# **8XC51SL**

## **SPECIFICATION UPDATE**

Release Date: July 1996

Order Number: 272877-001

**9600007. 8XC51SL-BG Reset Errata**

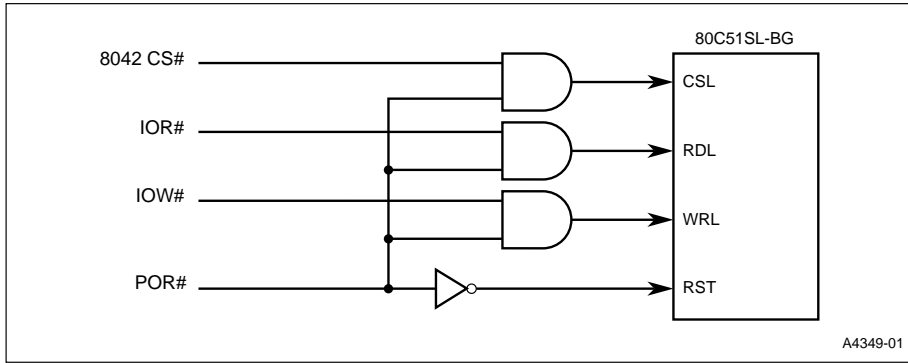
**PROBLEM:** Intel has confirmed that there is an intermittent reset problem with the 8XC51SL-BG. Abnormal ALE, PSEN, and Address have been observed after reset, and in some systems several of the Port 3 pins have toggled during reset.

**IMPLICATION :** During any of the 8XC51SL-BG resets listed, a floating node within the 8XC51SL-BG may cause internal clock signals to be killed thus not allowing a valid reset.

**WORKAROUND:** Workaround #1 (external logic: 3 gates). This is Intel's recommended workaround.

Drive the 8XC51SL-BG CSL, RDL, and WRL pins low during RST to guarantee a valid RST reset (typically used for power-on reset [POR]). Driving these 8XC51SL-BG pins low during reset drives the floating node to a proper state which allows reset to occur. During the time CSL, RDL, and WRL are driven low, LED0, LED2, and PCOB0-7 will be driven low from the 8XC51SL-BG.

Driving CSL, RDL, and WRL low during RST ensures that a valid RST reset (POR) occurs. It is possible for the problem node to float during non-RST resets after it has been initially set during a RST reset with the workaround in place. If this occurs the system user will have to issue one or more additional resets if the first non-RST reset fails. However, bench test experimentation has shown no reset failures after a valid PD was applied to RST with the workaround in place. The tests were conducted at room, hot, and cold temperatures for over 8 hours with several million software resets issued. Your system should be verified to confirm that no quality issue exists on the non-RST resets after implementing this workaround. The following figure shows a typical implementation of this work around.

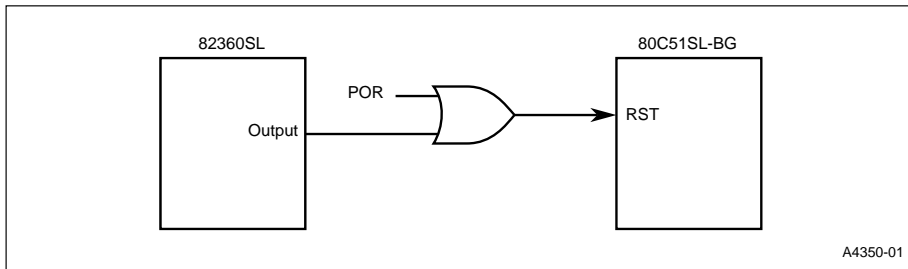
Workaround #2 (System BIOS modification, blue-wire, plus potential OR-gate). This is an alternative workaround.

Drive the 8XC51SL-BG RST input with a presently unused 82360SL output (blue-wire). If a valid 8XC51SL-BG reset is not detected (POST code error), the 82360SL will issue another reset to RST. Each system should be tested to ensure that having the 8XC51SL-BG powered before properly being reset does not cause any system problems. It may be beneficial to OR the present POR reset (if applicable) with the 82360SL system BIOS controlled reset signal to minimize this occurrence.

As with workaround #1, this workaround only directly addresses the RST reset and Intel recommends that each system model be tested to ensure that no quality issue exists with the additional reset sources.

The following figure shows a typical implementation of this workaround.
